COLORADO
**Division of Reclamation,
Mining and Safety**
Department of Natural Resources

RE: Hayden Gravel Pit, AM-04, Permit No. M-1987-164; AM-04 Application Adequacy Response

On June 2, 2023, the Division of Reclamation, Mining and Safety (Division) received your adequacy response letter for the Hayden Gravel Pit Amendment 4 (AM-04), File No. M-1987-164. The Division has reviewed the above referenced amendment adequacy review response letter and material submitted. The following is a list of the adequacy review items from the Division's April 7, 2023 first adequacy review letter followed by the response provided by Oldcastle SW Group, Inc. dba United Companies (UC). If additional information or revision is required it will be noted. If an item is resolved, that will be indicated.

Figure 1: Reclamation Map F-1 for the Hayden Gravel Pit which depict new permit boundary lines as part of AM4. Red box highlights the portion of the southern boundary line referenced above.

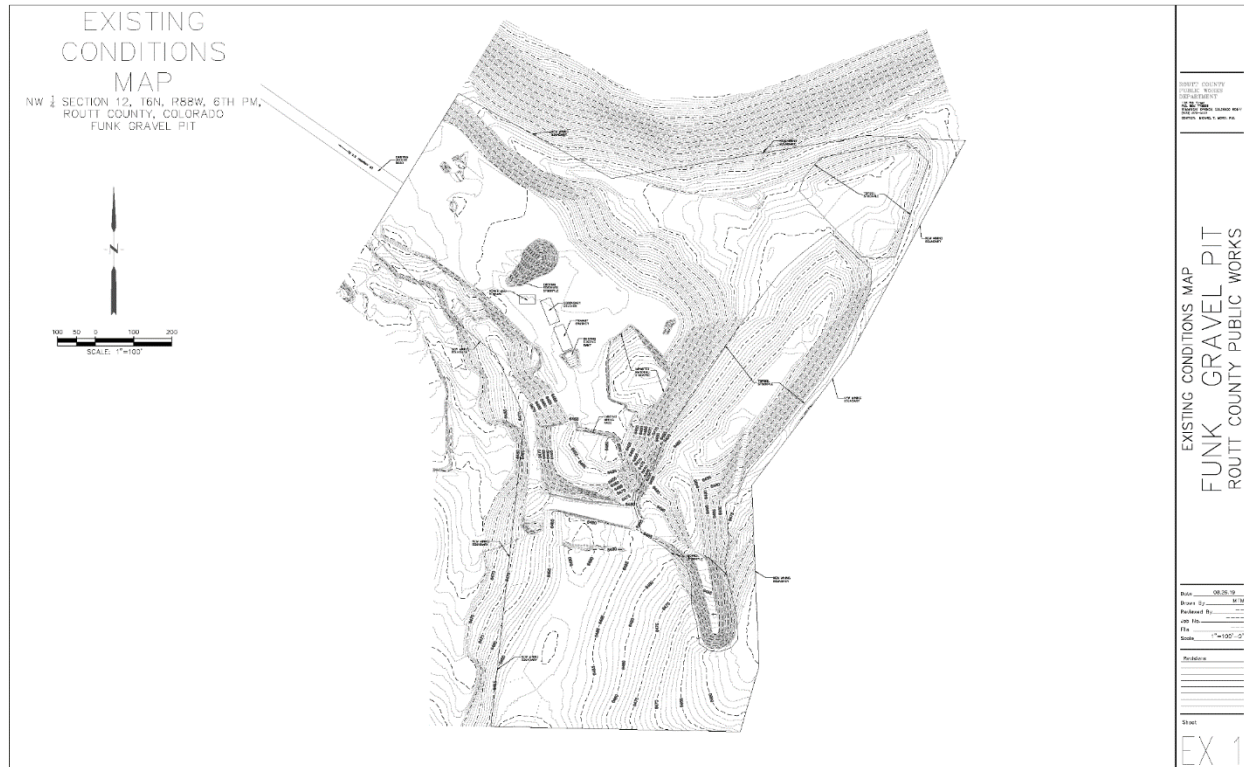
- a. UC Response:** See the response provided above.
 - b. Division Response: Resolved**
23. The Reclamation Map F-1 and other maps provided depict a southern portion of the proposed permit boundary (Figure 1) which appears to overlap with land which is currently permitted under another DRMS permit (Figure 2) held by Routt County, the Funk and Hooker Pit (M-1979-058). Please clarify if this boundary (Figure 1) is drawn in its intended location. DRMS will not permit over the county’s existing permit if this is the case. Please revise all permit boundaries shown on maps to reflect either a corrected or new permit boundary line.

- a. **UC Response:** United Companies is pursuing an agreement with Routt County Road and Bridge to release this overlapping area for the haul road. This agreement will be provided to the DRMS once it has been obtained.
- b. **Division Response:** This Division will accept this arrangement. However, this agreement and its required revision must be completed through the Division by the decision deadline date of August 11, 2023, unless otherwise extended, in order for AM-04 to be approved.
